3.0 DRAWINGS AND DESCRIPTION OF PROPOSED CHANGES

3.2 BUILDING 2 GROUND FLOOR - OPTION B

LOCATION	
job title TOTTENHAM HALE CENTRE ISLAND SITES drawing title / location PROPOSED MEZZANINE FLOOR PLAN - OPTION B	
drawn by MG	checked AM
scale 1 : 250@A1 , 1 : 500@A3	status FOR APPROVAL

TOTTENHAM HALE CENTRE
ISLAND SITES
PROPOSED L01 FLOOR PLAN

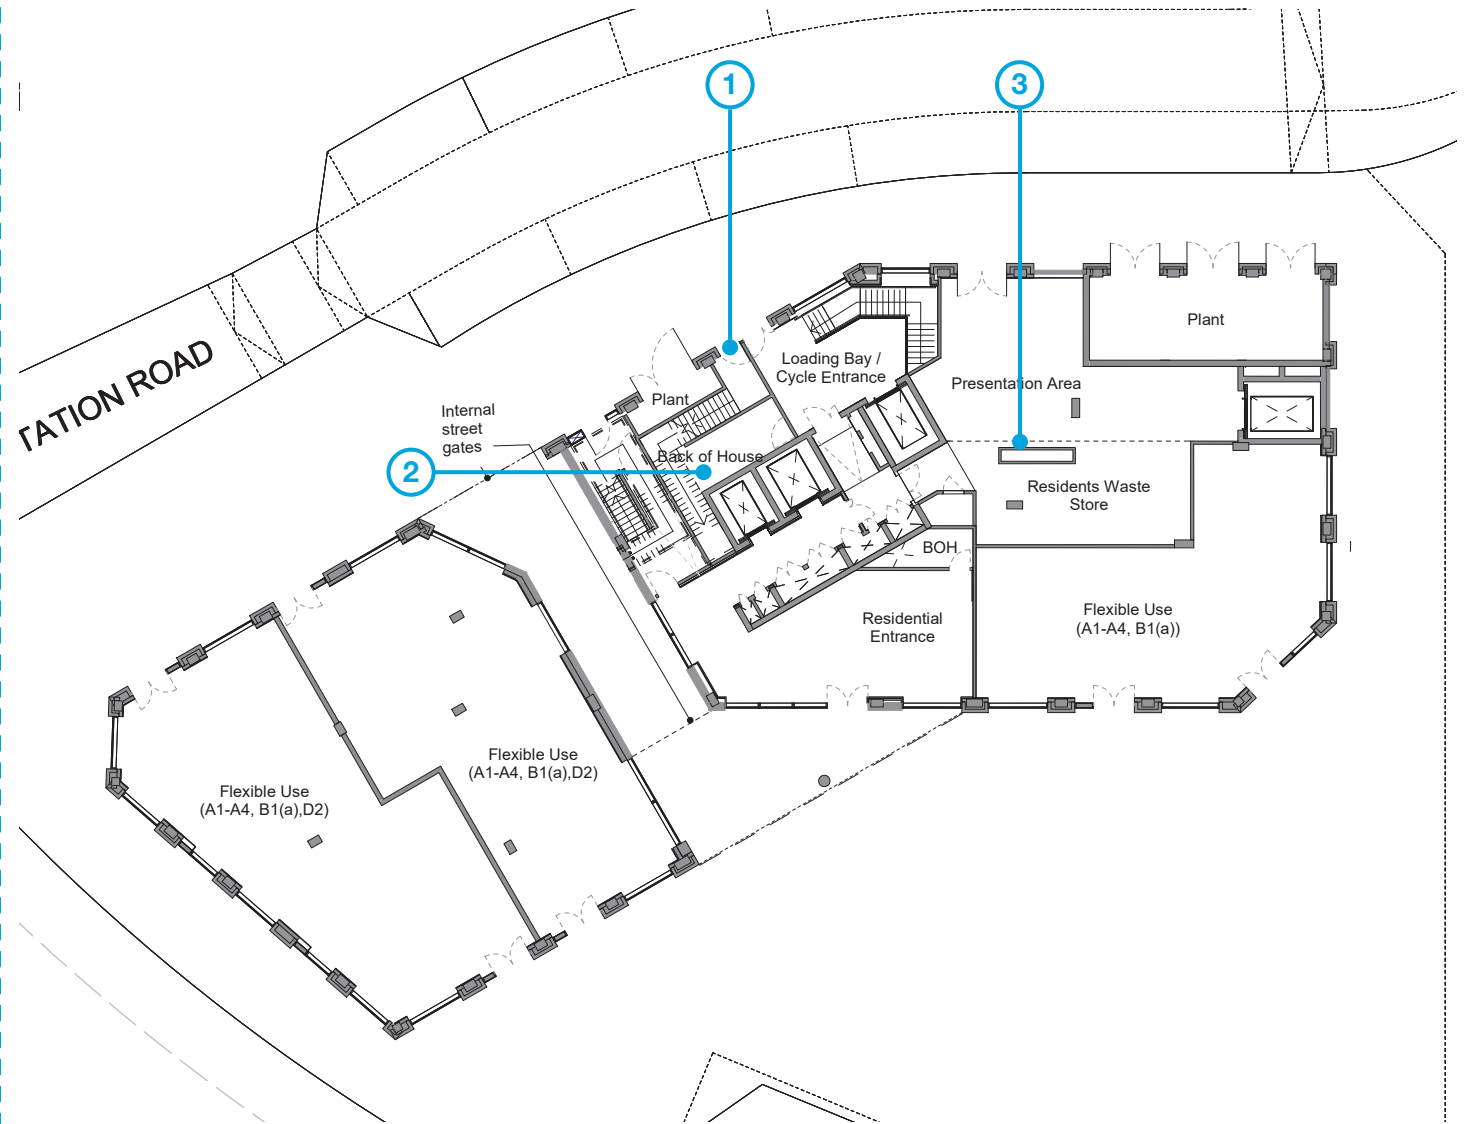
1. Addition of an additional fire escape providing egress from the second staircase.
2. Back of house arrangement has been updated to respond to the introduction of the second stair.
3. Service risers have been relocated within the core following the addition of the second staircase.

3.3 BUILDING 1 MEZZANINE - OPTION B

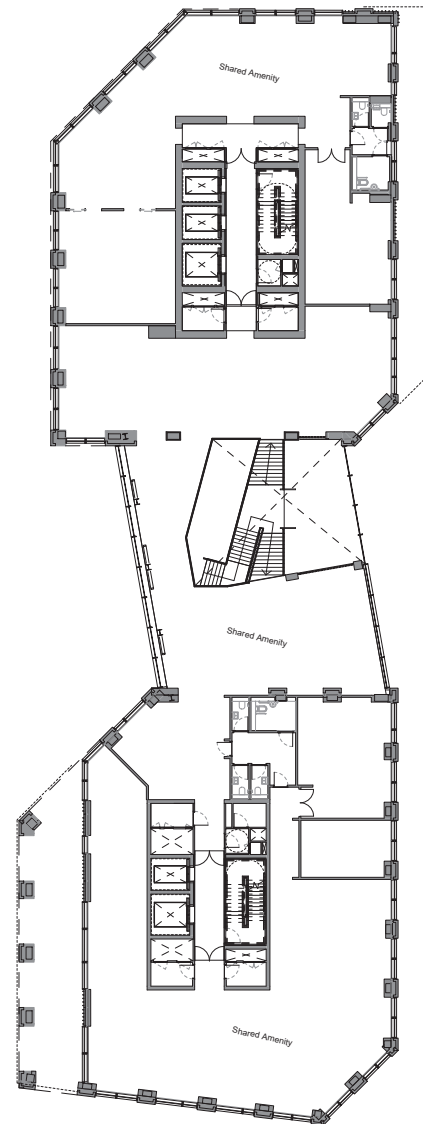
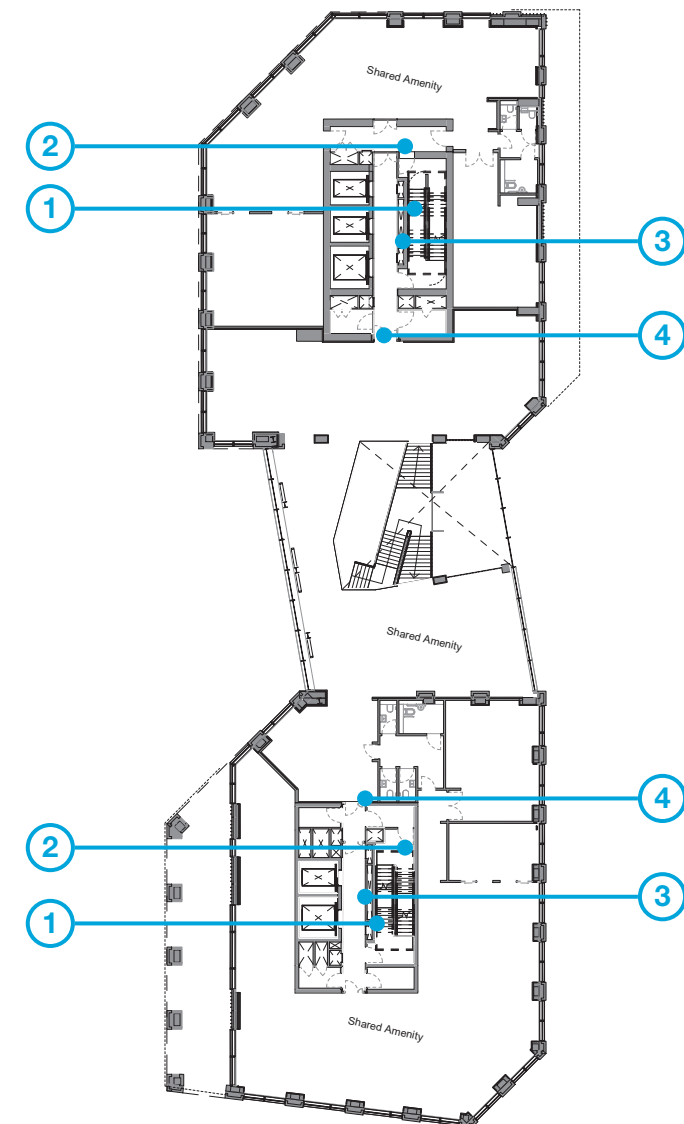
1. A second fire escape stair has been added between ground floor to upper levels.
2. Due to the addition of the second stair, the position of the access to the stairs has changed to resolve level changes across all floors.
3. Service risers have been relocated within the core following the addition of the second staircase.
4. Additional doors have been added within the communal corridors to comply with the latest fire strategy.
